RE: CUYAHOGA COUNTY
CITY OF WESTLAKE
LEE BURNESON WESTLAKE
MIDDLE SCHOOL
CONSTRUCTION STORM WATER
PERMIT NO: 3GC05331

INSPECTION PHOTOS

Lee Burneson Westlake Middle School

Figure 1&2: Spilled oil and greasy equipment on ground

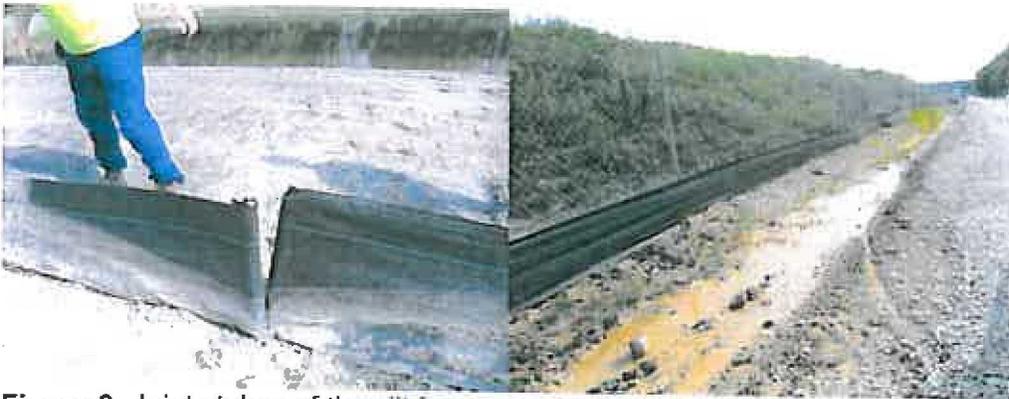
1. There was an oil spill and greasy equipment on the ground. Contaminated soil must be disposed of in a solid waste dumpster. The greasy equipment should be stored in a dyke or covered with a tarp to prevent contamination of water. Check equipment and maintain proper spill prevention techniques throughout construction.
2. The silt fence that has been installed around the sediment basin needs to have the joint stakes twisted together. Please twist the stakes together then re-stake them into the ground.
3. Keep ditches free of trash and debris. Practice good housekeeping.
